Access Compliance Report

Public Rights-of-Way

(Curb Ramps)

Intersection ID: 47977	Main Street: AVALY_LN	Cross Street: SPRINGS_MILL_RD	Location: NW
ADA ID: FC3AC9E0F38F	Ramp Type: PerpDiag	Initial Pass/Fail: Fail	Overall Compliance: No
Severity Score: 8.75			
Codes/Mitigation Info/Possible Solution		Field Measurements/Component Compliance

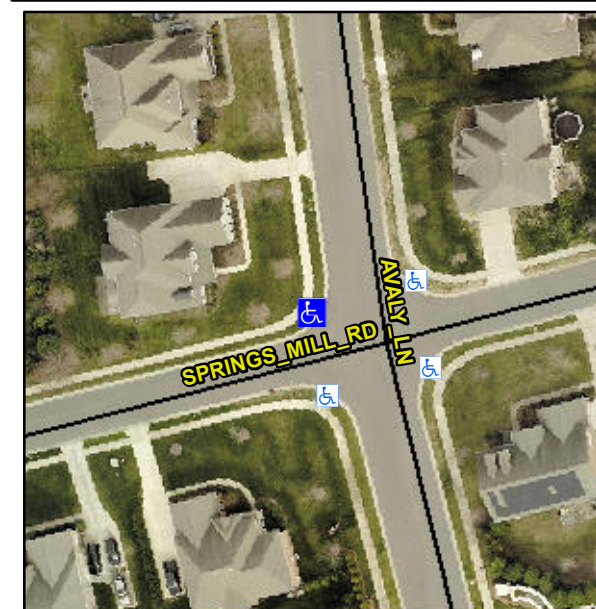
Compliance	Description	Data	Compliance	Description	Data
N/A	Ramp Length (in)	62.0	Yes	Ramp Slope (%)	6.0
No	Ramp Width (in)	47.0	Yes	Ramp XSlope (%)	0.8
N/A	Flare Type LT	N/A	N/A	Flare Type RT	N/A
N/A	Flare Slope LT (%)	N/A	N/A	Flare Slope RT (%)	N/A
N/A	Flare Traversable LT?	N/A	N/A	Flare Traversable RT?	N/A
N/A	Landing Length (in)	N/A	N/A	DWS Provided?	N/A
N/A	Landing Width (in)	N/A	N/A	DWS Contrast?	N/A
N/A	Landing Slope (%)	N/A	N/A	DWS Length (in)	N/A
N/A	Landing X Slope (%)	N/A	N/A	DWS Full Width?	N/A
N/A	Landing Curb? (Y/N)	N/A	N/A	DWS Offset (in)	N/A
N/A	Shared Landing?	N/A			
N/A	Gutter Ponding?	N/A	N/A	Gutter Slope (%)	N/A
N/A	Gutter Lip Ht (in)	N/A	N/A	Gutter X Slope (%)	N/A
N/A	Painted X Walk1?	No	N/A	Painted X Walk2?	No
	X Walk 1 Direction	To S		X Walk 2 Direction	To E
N/A	X Walk 1 Width (in)	N/A	N/A	X Walk 2 Width (in)	N/A
	X Walk 1 Slope (%)	2.0		X Walk 2 Slope (%)	1.8
	X Walk 1 X Slope (%)	1.8		X Walk 2 X Slope (%)	1.0

N/A	Ramp inside XWalk1?	N/A	N/A	Ramp inside XWalk2?	N/A
	Road Slope (%)	1.4	N/A	Clear Space?	N/A
	Road X Slope (%)	1.2	N/A	Clear Space to XWalk (in)	N/A
N/A	Any Obstructions?	N/A	N/A	Storm Grate/Utility Hazard?	N/A
	Obstruction Type			Storm Grate/Utility Type	
		N/A			N/A
			Yes	Surface Condition? (G/P)	Good

Remove & Replace Curb Ramp With Two New Directional Ramps or Equivalent.
